# AIA Document G701™ – 2017

## Change Order

**PROJECT:** (Name and address)  
Williamson County  
Animal Shelter Expansion  
1855 SE Inner Loop  
Georgetown, TX 78626

Change Order No. 3 includes the below listed Vaughn Change Proposals # 11-#17. For Vaughn Project No. 2491-01.

**A.3-5.41**

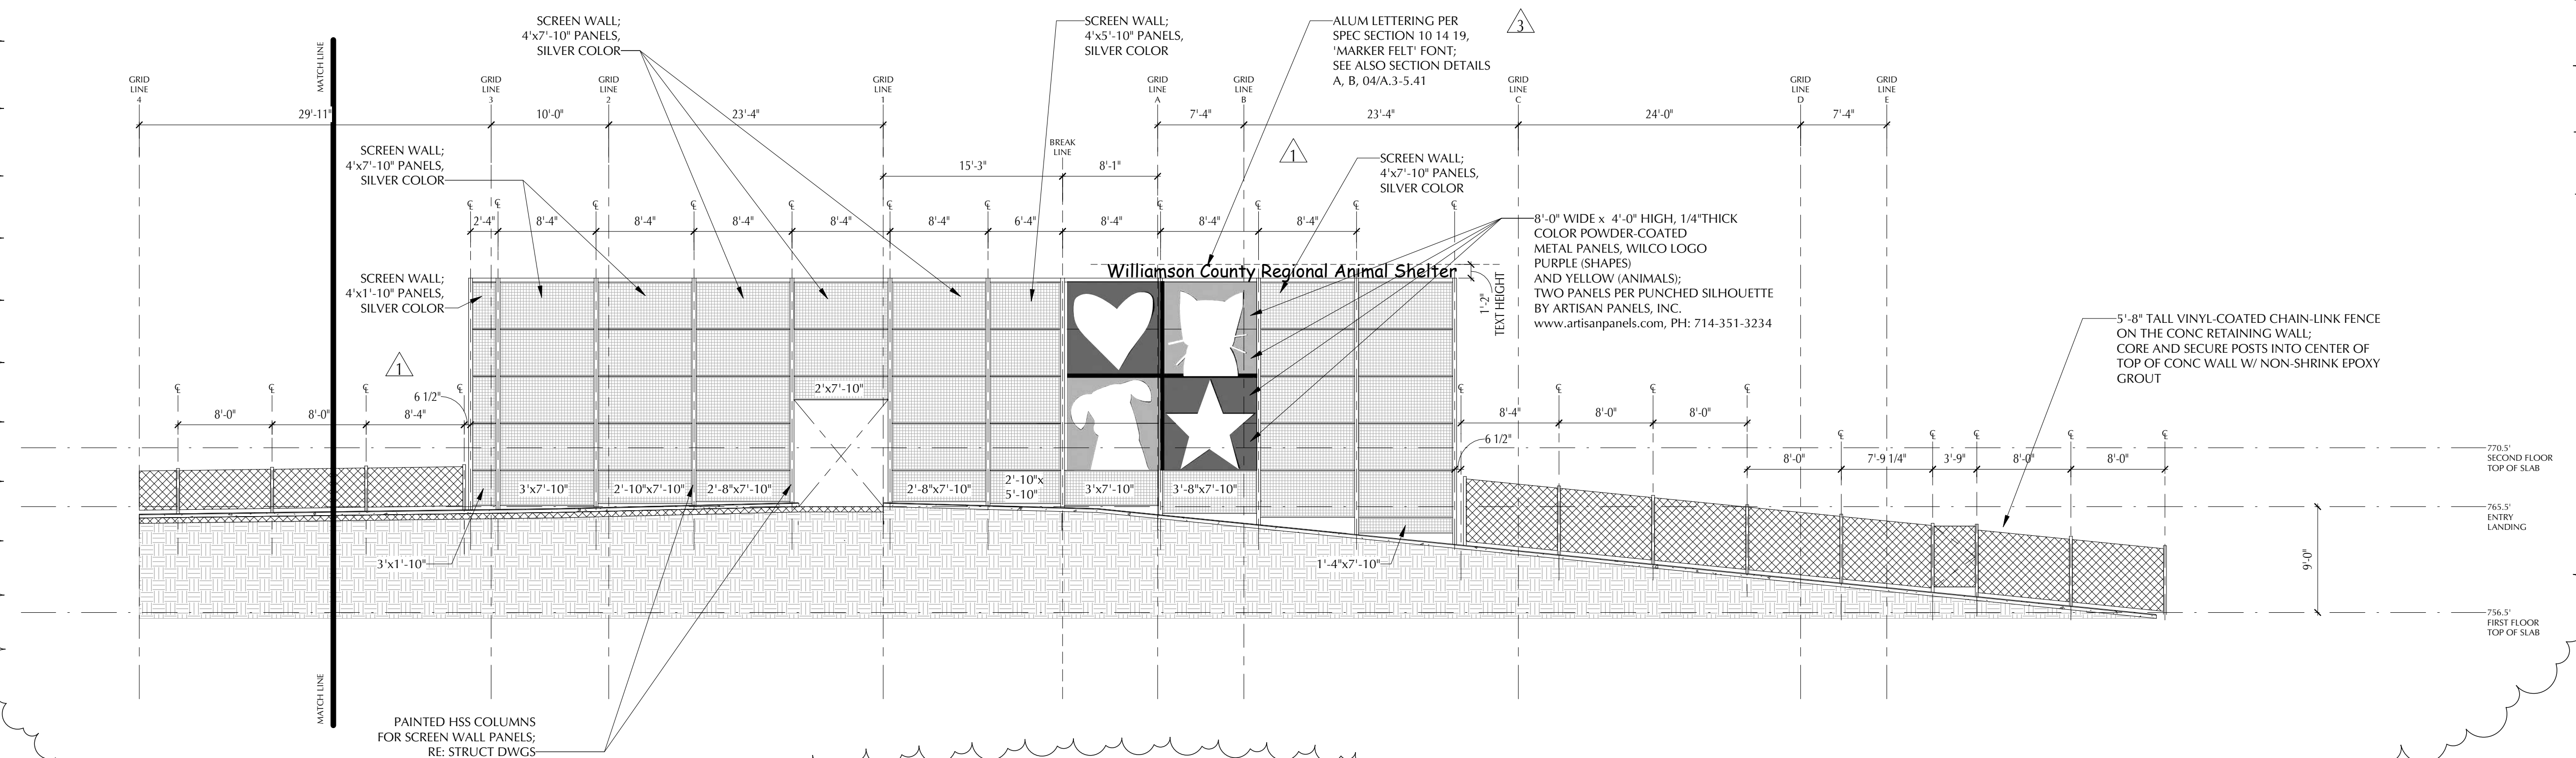
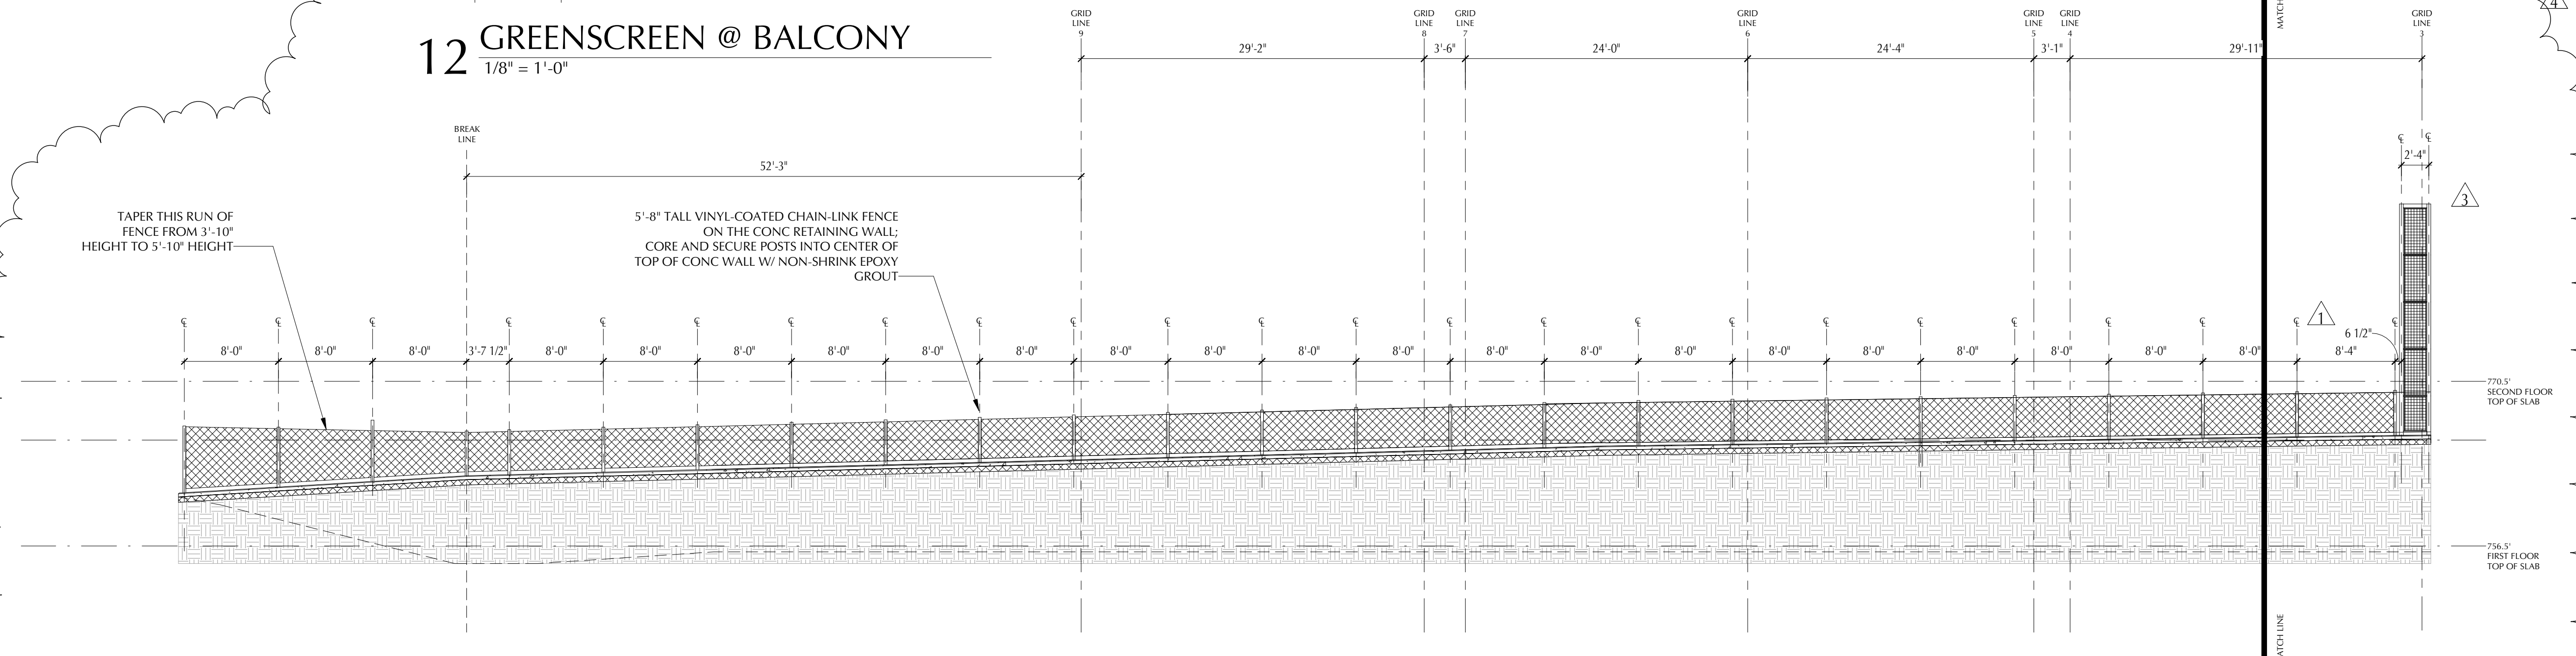
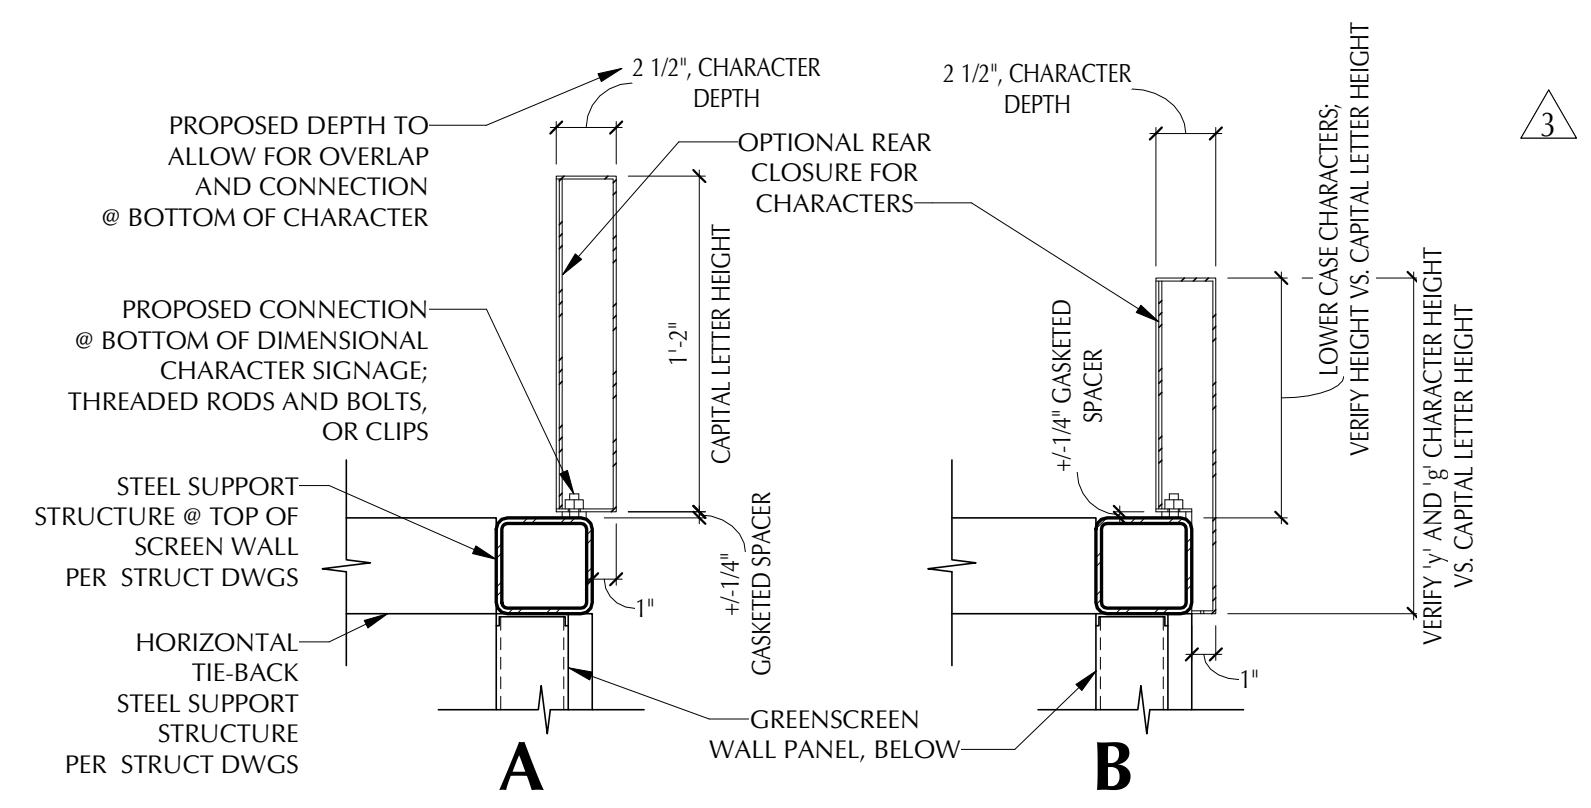
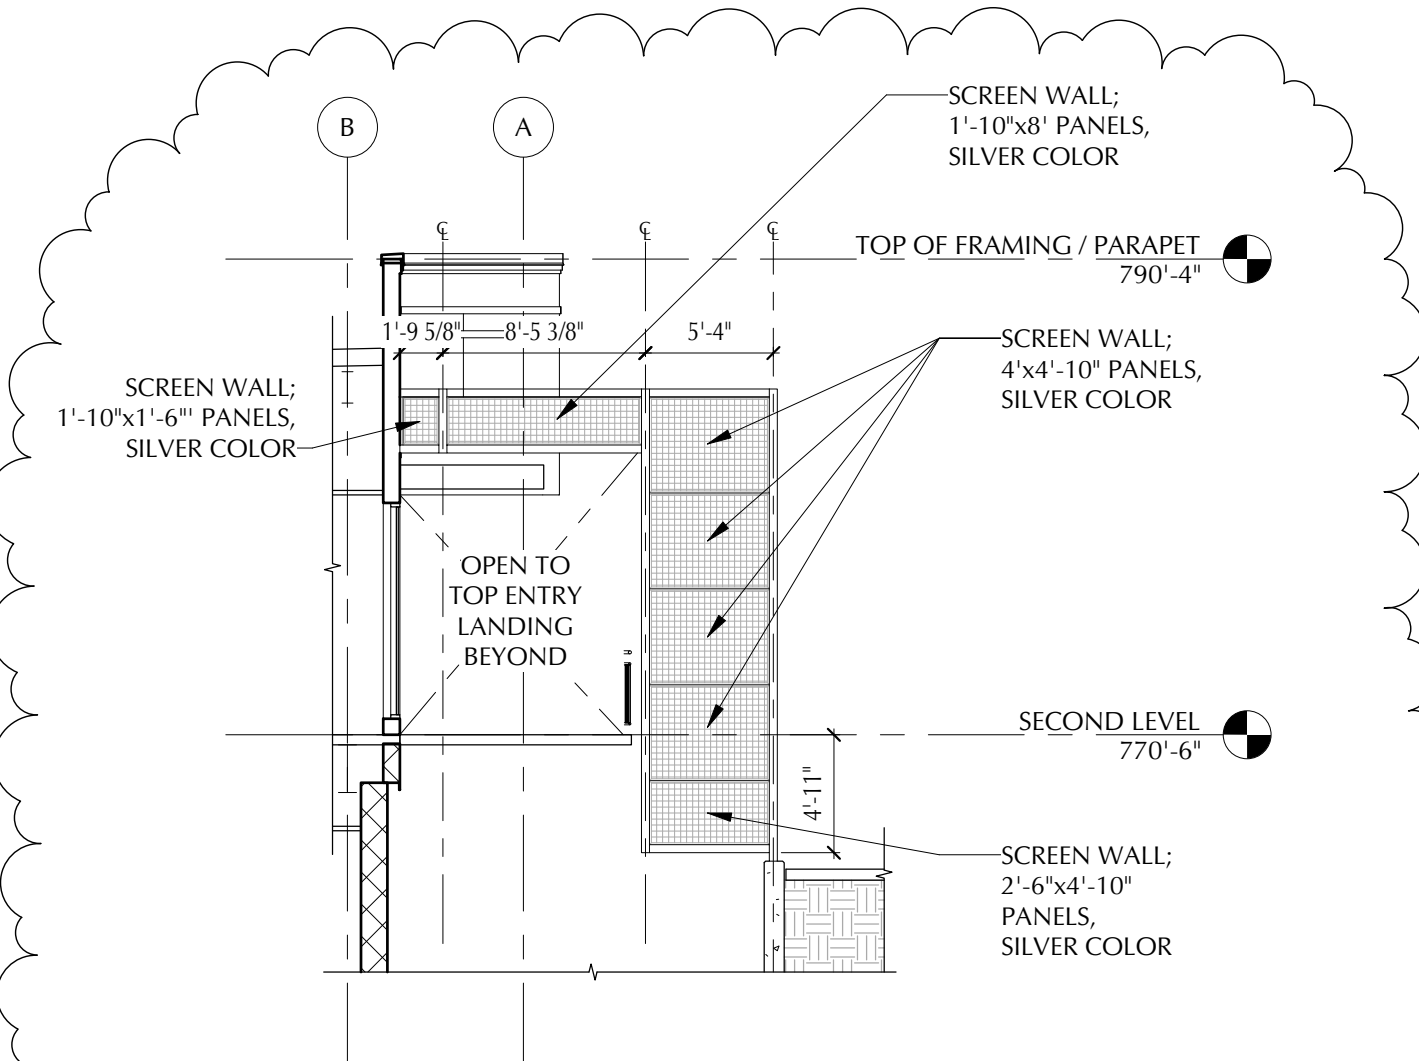
1) Reference detail 03 A.3-501 West Elevation- New adoption building and sheet S.3-2.03. The vertical columns on the structural differ from the elevation detail. Please advise if the structural is showing the correct columns and spacing or if the elevation is incorrect. If incorrect, please furnish correct elevation vie for Greenscreen.

2) Reference sheets S.3-2.03, A.3-5.40, A.3-5.42, A.3-5.41 and attached Greenscreen detail. Typical Greenscreen panels are 8 ft wide and require 1/2" clear space per side to accommodate the mounting brackets (see attached). With the 4" HSS columns, the 8'4" spacing from center of post to center will not be enough to install the panels as recommended. The spacing will need to be 8'5" center of column to column. Can the typical spacing for the columns be changed and the end sections at each run be reduced to accommodate this?

The greenscreen panels wrap around the top landing of the Public Entry, and have a west elevation at the east end of the Balcony canopy. See new elevation 12/A.3-5.41. The steel shown on this elevation is accounted-for in the Structural Framing shop drawings.

The spacing for the greenscreen support columns will remain as-drawn, and each panel can instead be reduced in width by 2". See revised drawing sheets A.3-5.41 and A.3-5.42 for updated screen wall and retaining all elevations which coordinate w/ the site grading on the approved Site Development drawings.
